## 1101 Universal Transmitter

November 2016

### Hardware Update

Figure 1: 1101 Universal Transmitter Case Design

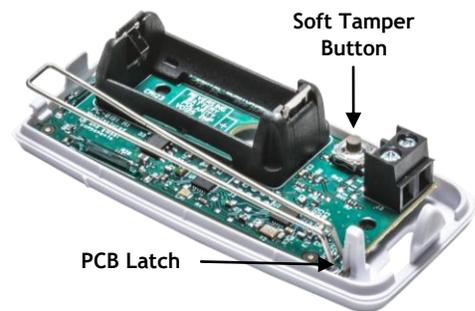
The 1101 case now features a streamlined plastic design that is easy to open and close. To open the case, press the button on the end of the 1101 and gently pull up on the transmitter cover. See Figure 1.

The 1101 no longer uses a spring to trigger the case tamper. The new design includes a built-in case tamper post which activates the soft tamper button on the PCB.
